WATER QUALITY MEMORANDUM

Utah Coal Regulatory Program

RE: 2011 Second Quarter Water Monitoring, Genwal Resources, Inc., Crandall Canyon Mine, C/015/0032, Task ID #3834

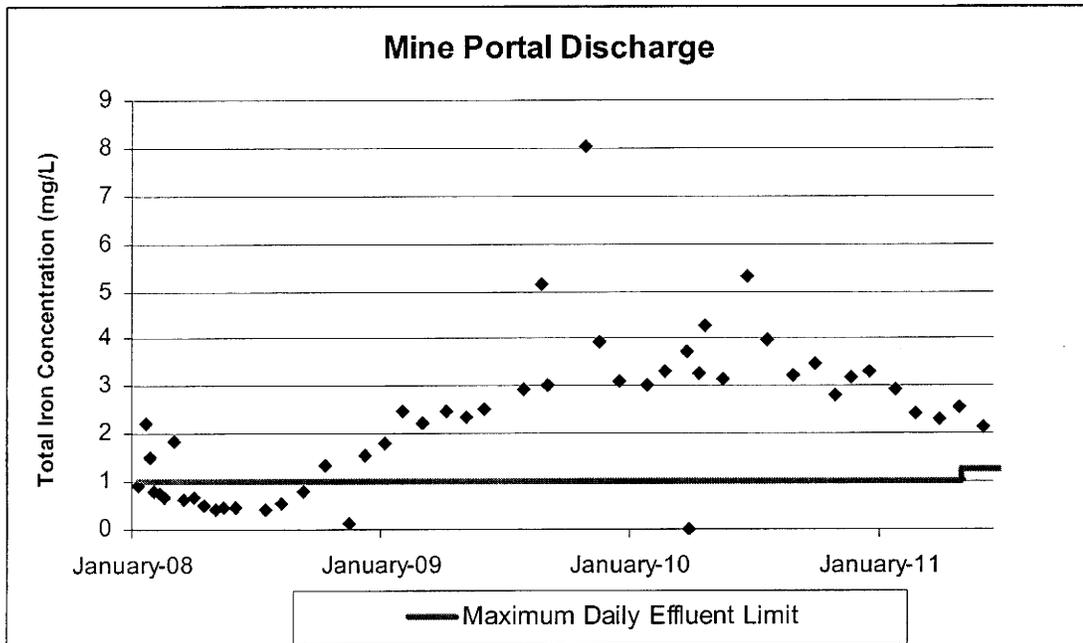
As the total iron (T-Fe) concentrations in the mine-water discharge began to increase, a concern was that a similar rise would be observed in stream monitoring site Lower Crandall Canyon Flume (LOF-1). An upward trend of T-Fe began to surface the second quarter of 2008 in correspondence with the increase in iron concentrations of the mine-water discharge. A T-Fe concentration of 1.479 gpm was reported the fourth quarter of 2009. Once the mine-water treatment system became operational during the 1st quarter of 2010, the iron concentrations detected at LOF-1 have dropped significantly. The T-Fe concentration for LOF-1 this quarter was 0.37 mg/L.
